The amendment changes the Technical Specifications to establish revised safety and operating limits for operation of Brunswick Unit No. 2 during fuel Cycle Number 5.

BRUNSWICK STEAM ELECTRIC PLANT, UNIT NO. 2

AMENDMENT TO FACILITY OPERATING LICENSE

Amendment No. 71  
License No. DPR-62

FIGURE 3.2.1-7

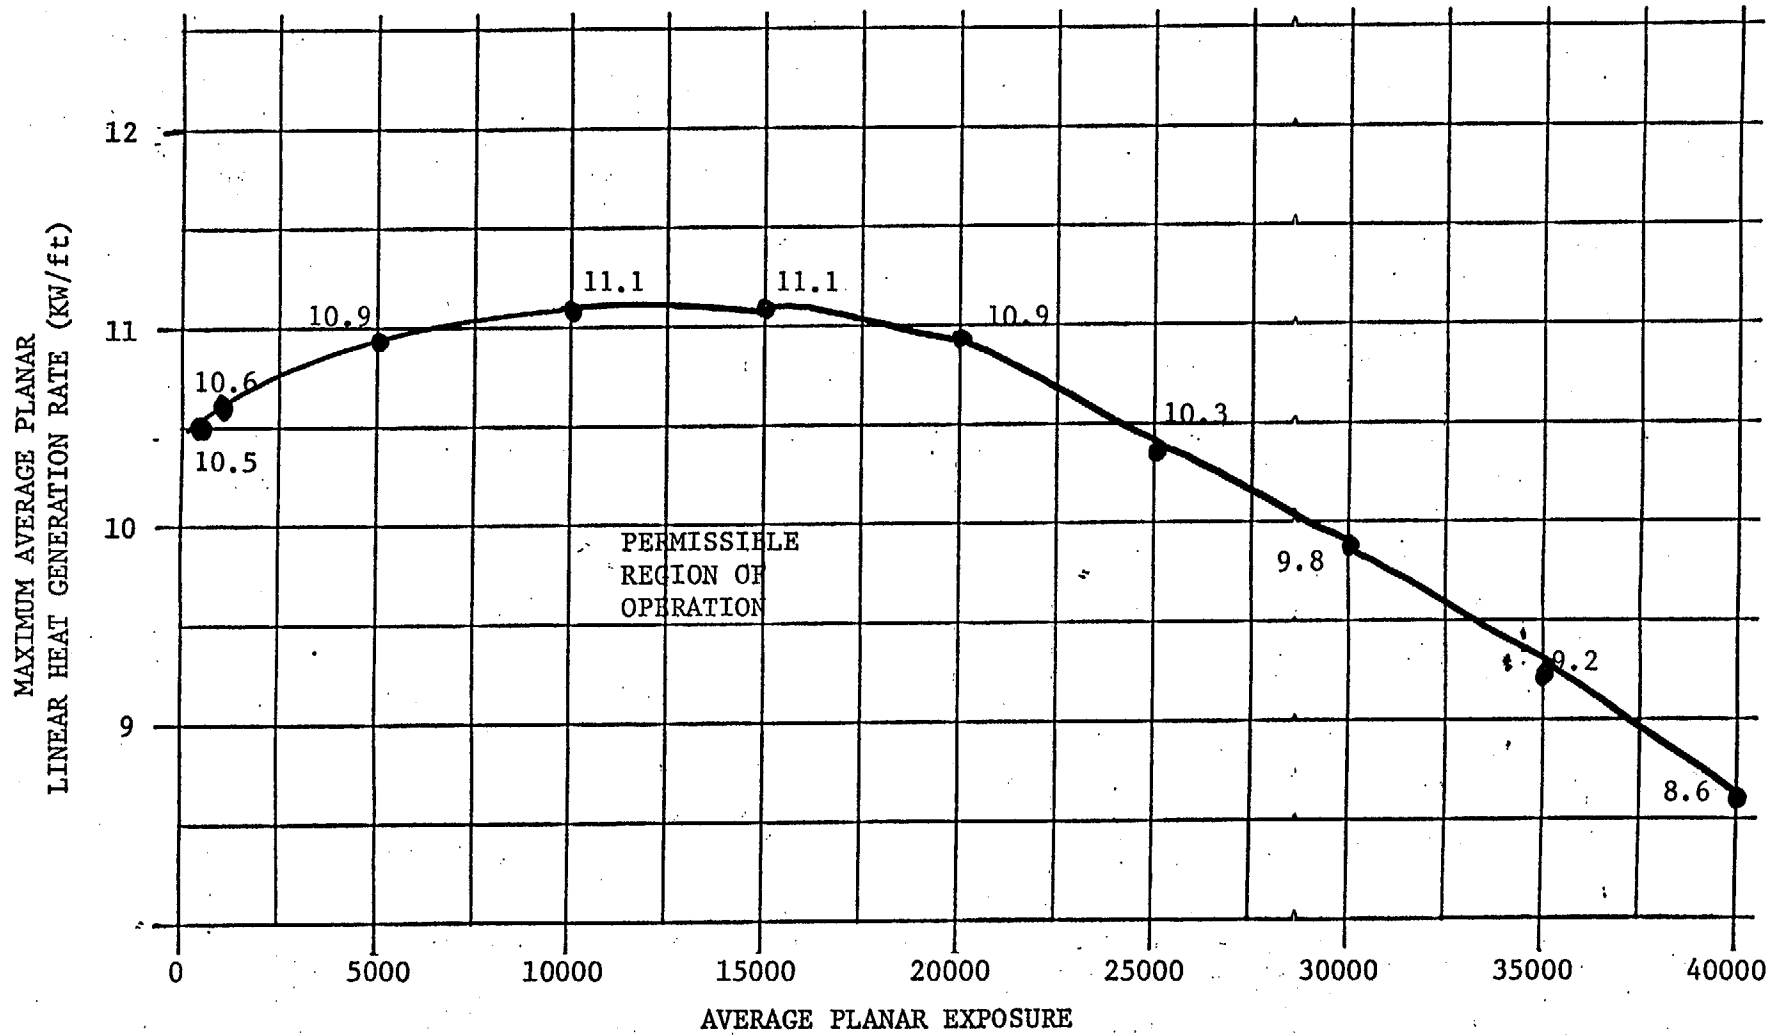
\* These limits differ from those found in General Electric reports Y1003J01A37, March 1982, "Supplemental Reload Licensing Submittal for Brunswick Steam Electric Plant, Unit 2, Reload 4," (with and without RPT) due to a MAPLHGR reduction penalty imposed by NRC due to core spray sparger cracking.

NOTE: SEE FOOTNOTE FOR SPECIFICATION 3.2.1.

FIGURE 3.2.1-8

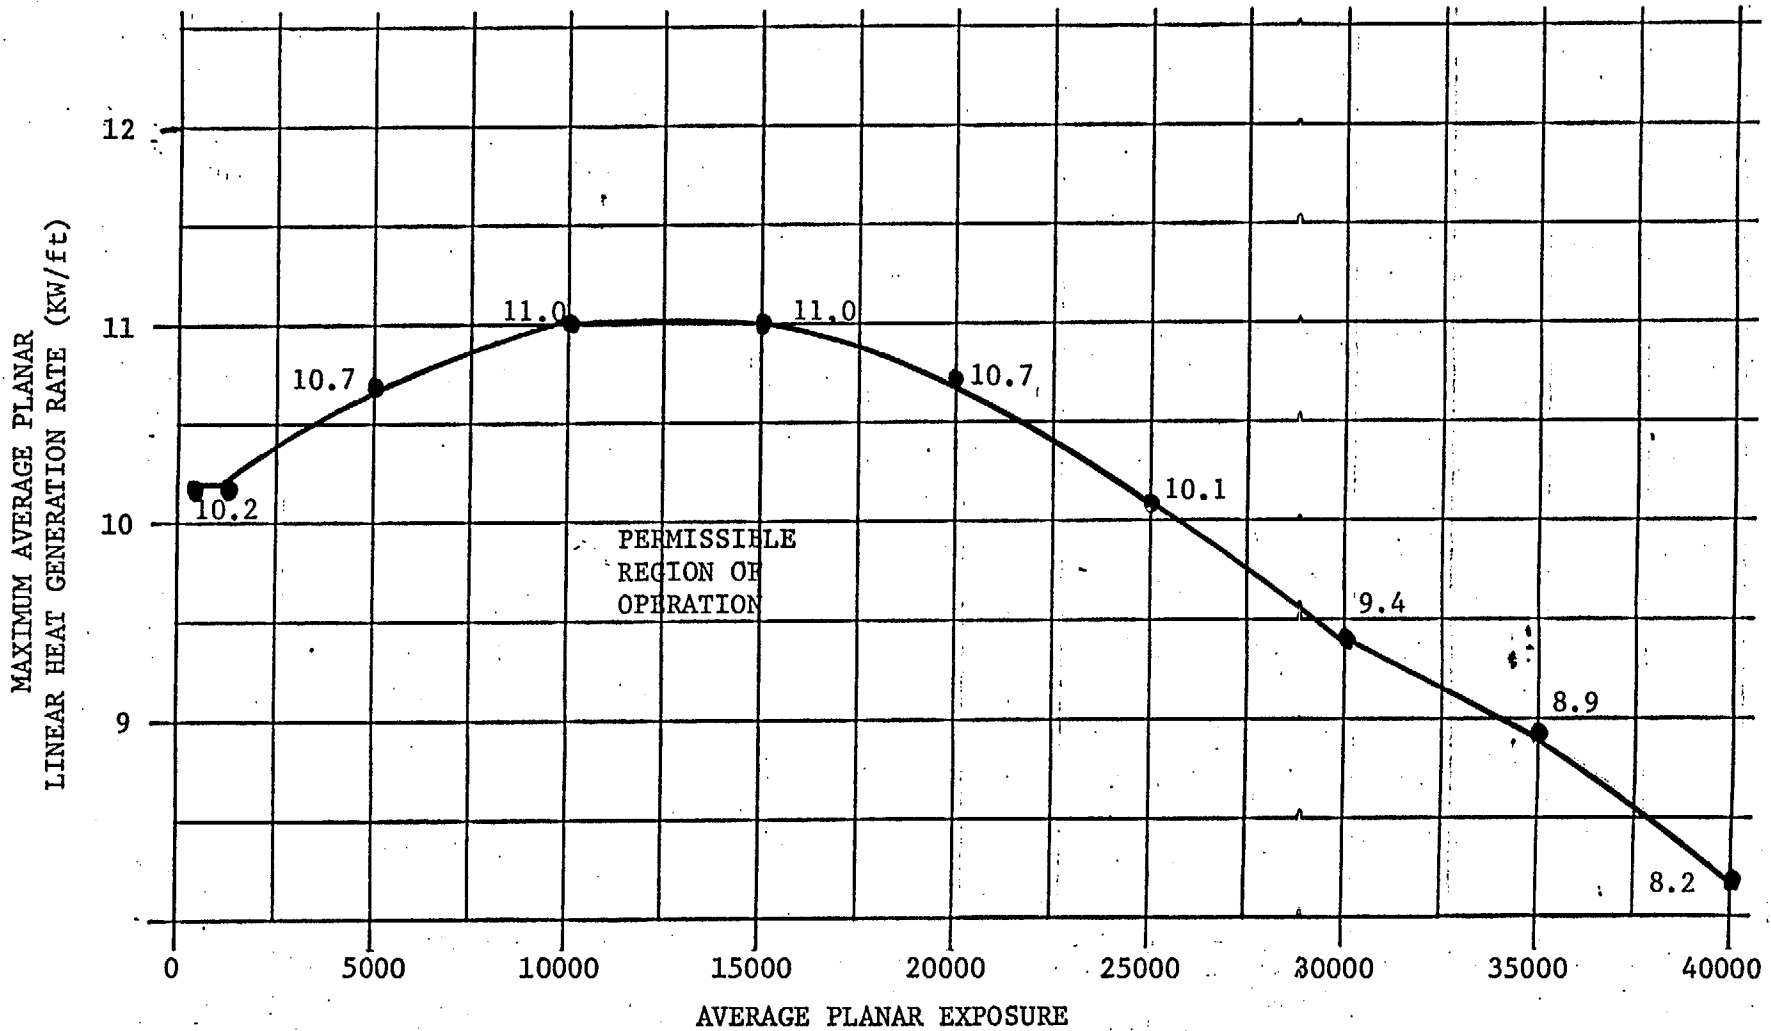
NOTE: SEE FOOTNOTE FOR SPECIFICATION 3.2.1.
